Application by RWE Renewables UK Solar and Storage Limited for an Order Granting Development Consent for the Byers Gill Solar Project. PINS Reference No: EN010139.

BVAG Deadlines 9 & 9A Responses

Bishopton Villages Action Group Closing Statement

OPTIONS FOR HYBRID INVERTER SYSTEMS

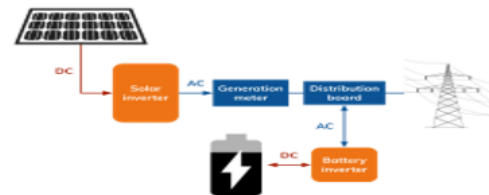
<p>Whilst a normal Inverter can charge batteries using power from the grid or a generator, it cannot charge batteries using solar power. It is not designed to interact with the grid beyond providing backup power during outages.</p> <p>A normal Inverter does not have advanced energy management features. It simply converts DC power to AC power and supplies it to the connected load. It provides backup power during outages but relies on the grid as its primary power source.</p> <p>Q5. With the above in mind, please provide explanation why the proposed system is using 44 standard Inverters alongside 53 Hybrid Inverters when if all Inverters were of the Hybrid type then a substantial reduction in panels and land use could be made.</p> <p>Q6. Is the Applicant intending to use any Off-Grid Inverters? If so how many will be installed? Also, why, when Off-grid inverters are not designed to interact with the utility grid as they do not have the ability to export energy to the grid or receive energy from it?</p> <p>The size of a solar system is measured in kWp (kilowatt peak). It is the amount of power produced under standard laboratory test conditions, which broadly equate to bright sunshine. So a 2 kWp system will produce 2 kW of electrical power in bright sunshine.</p> <p>Q7. Protection devices within Solar Power Systems are very important as without them, undesired situations starting from fire hazard or dangerous health situations can occur. Please could the Applicant confirm: Size of Overcurrent Protection Devices, Fuses, Breakers in the Systems?</p> <p>The Applicant's calculations are apparently based on the use of Jinko 571watt 2278mm x 1134 panels.</p> <p>BVAG's calculations indicate that a typical Ratio applied to the proposed system of 1.2 to 1.3 would suffice based on the 95% efficiency resulting from the use of Hybrid Inverters for AC-DC coupling instead of AC coupling.</p> <p>BVAG's calculations also indicate that the Applicant has indicated that they have calculated 505,876 panels are required to meet their obligations regarding an 180Megawatt supply connection with National Grid at Letch Lane.</p> <p>This gives approximately 288Megawatt AC supply output obviously derived from the application of the use of the 1.6 Ratio.</p> <p>The Applicant has not responded to all requests on the above to date.</p> <p>The use of 97 Hybrid Inverters each of 2.1KW is of some concern as they would provide an AC output of 203.7 Megawatts AC.</p> <p>If the 1.6 Ratio is applied at this point then the maximum output of the panels equates to 325.9 Megawatt.</p> <p>The Applicant has indicated that there will be no power clipping or power wasted in their final design and build. This would suggest that the Applicant intends to install oversized BESS battery packs to accommodate the excessive power produced.</p> <p>Q8. Can the Applicant please confirm the actual values and details of equipment proposed based on their proposed design?</p> <p>Preamble to Q10:</p>

Diagram Ref APP-048 '6.3.2.10 Environmental Statement Figure 2.10 Typical Inverter, Transformer and BESS arrangement

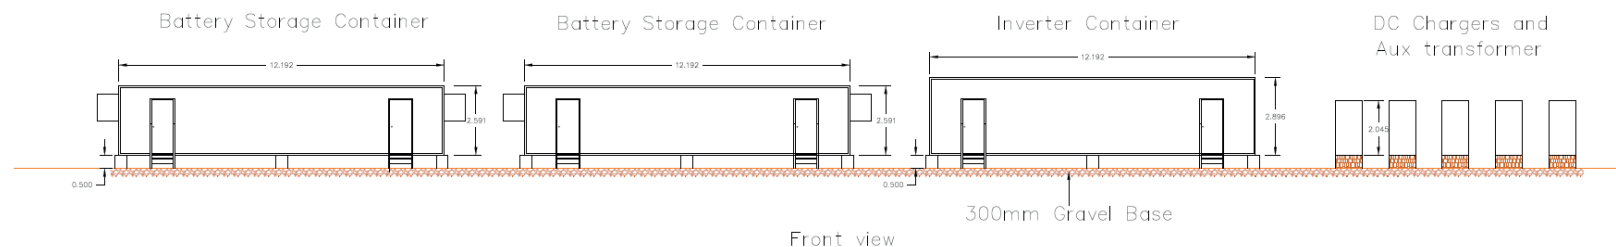
The Application describes 53 BESS units as part of 'hybrid units' with an inverter and a transformer across the site (Ref RWE DAD APP-165 superseded by AS-004). However, when looking at the design of the hybrid units in the DAD it appears as if each 'hybrid unit' has two batteries i.e. 106 battery units. Can the Applicant confirm / clarify this? See below extract from DAD of a 'hybrid unit':

- Q9. Can the Applicant please provide details of the Inverters, Battery packs and method of control that will both control and protect the systems?
- Q10. Can the Applicant confirm the total number of BESS units proposed to be installed throughout the Solar Site and type / size / capacity of the equipment housed in the BESS units?

The Applicant has failed to provide a robust design solution throughout the DCO proposal: in failing to do so, they have possibly introduced a design which **compromises the safety and wellbeing of all of the local residents affected by the project.**
